Lot 139 ✓
Phase 2
Model Bella (40-3) Elev B ✓
CHANTAL CHARLES-RUSSELL and JAMES RUSSELL ✓

Colours Upgrade Report
Brooklin Print Date:17-Apr-13

**FINAL STRUCTURAL REQUEST
ACKNOWLEDGMENT**

LOT 139 BF

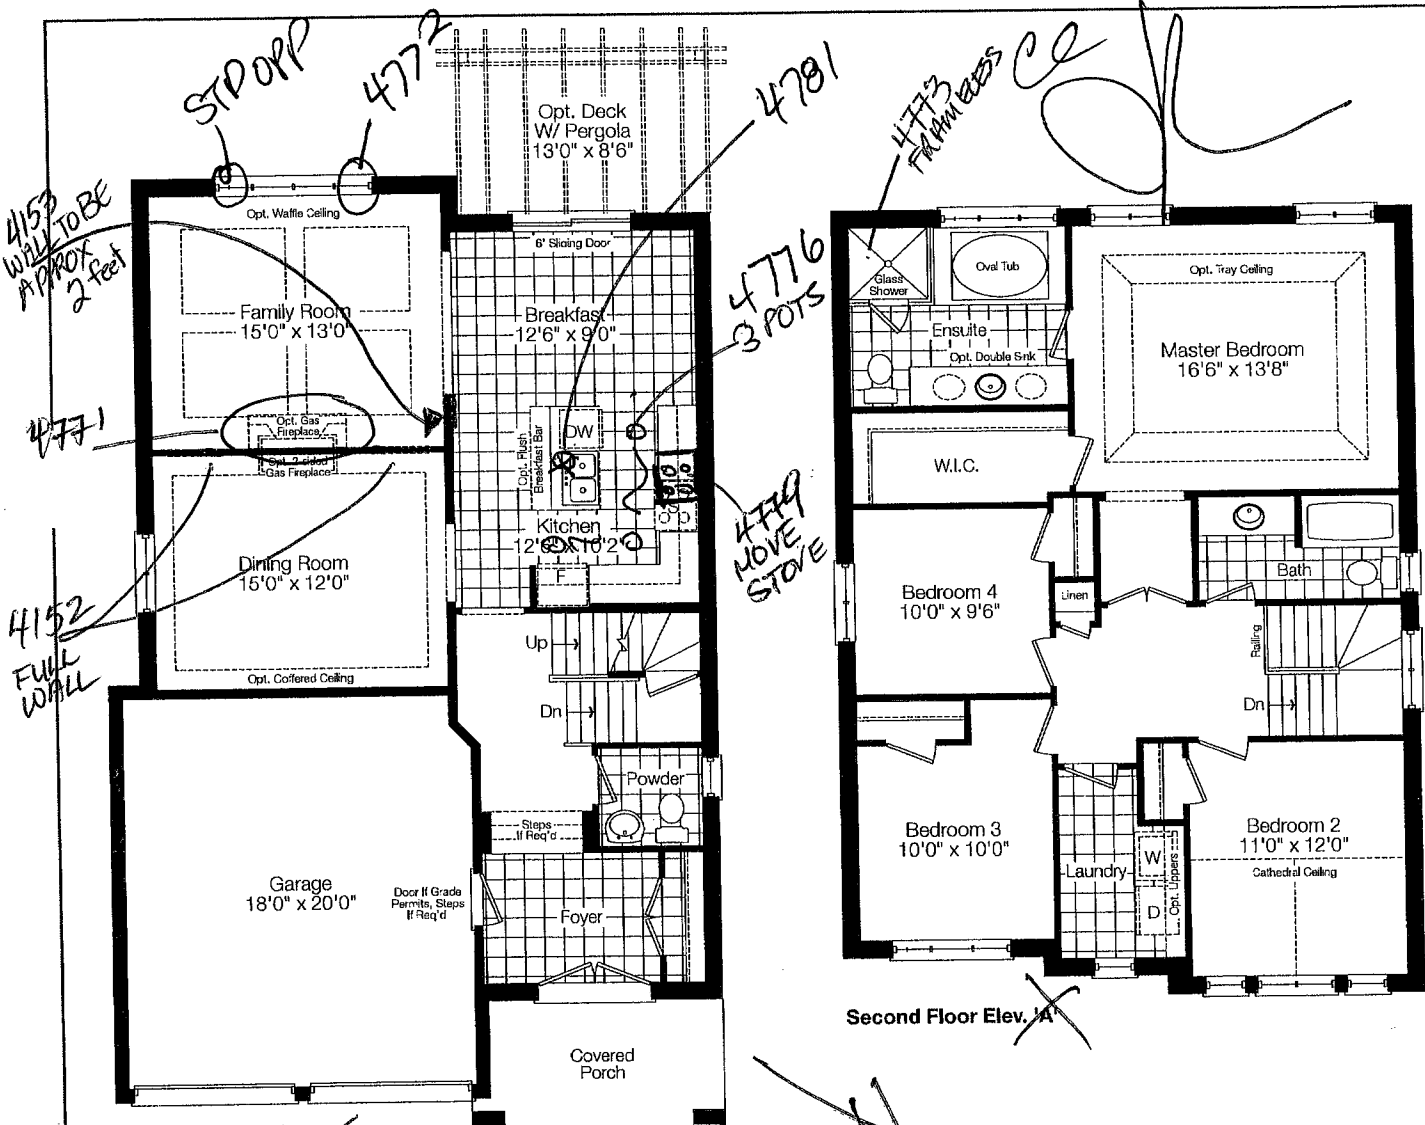
ID	Group	Description	Invoice	Date Ordered	
4152	INCLUDED IN OFFER	FULL WALL BETWEEN FAMILY ROOM AND DINING ROOM ✓	556		
4153	INCLUDED IN OFFER	EXTEND WALL APPROXIMATELY 2 FT. FROM FAMILY ROOM TO KITCHEN ✓	556		
4771	STRUCTURAL	Family Room: Fireplace box to be 18-20 inch deep. *Purchaser is aware mantle will stick out pass the 18-20 inch * 18inch does not include mantle lip ✓	648		SINGLE SIDED FIREPLACE
4772	STRUCTURAL	Family Room: Add additional opp window *See sketch ✓	648		
4773	STRUCTURAL	Master Ensuite: Frameless glass shower ✓	648		
4774	STRUCTURAL	Kitchen: purchaser declined gas line to stove *Purchaser will change electrical needed for stove after closing ✓	648		
4775	STRUCTURAL	Kitchen: waterline to fridge ✓	648		
4776	STRUCTURAL	Electrical: 3 STD potlights *See sketch ✓ KITCHEN	648		
4777	STRUCTURAL	Kitchen: deep uppers and 1 gable *STD cabinet pricing ✓	648		
4778	STRUCTURAL	All bathroom: no mirrors or bathroom accessories to be installed ✓	648

4779	STRUCTURAL	Kitchen: Move stove as per sketch. Center stove within lower cabinets ✓	648		APPROX 1.5-2 ft.
4780	STRUCTURAL	Kitchen: Purchaser request for bulkheads not to be installed ✓	648		
4781	STRUCTURAL	Electrical: Move STD light to be centered over island ✓	648		
4782	STRUCTURAL	Kitchen: Upper corner cabinet *STD cabinet pricing ✓	648		
4848	STRUCTURAL	Master Ensuite - Shower threshold - install glass on threshold so that 3 inches is left on the ledge on the inside of the shower. Purchaser wants a ledge for soap/shampoo ✓	648
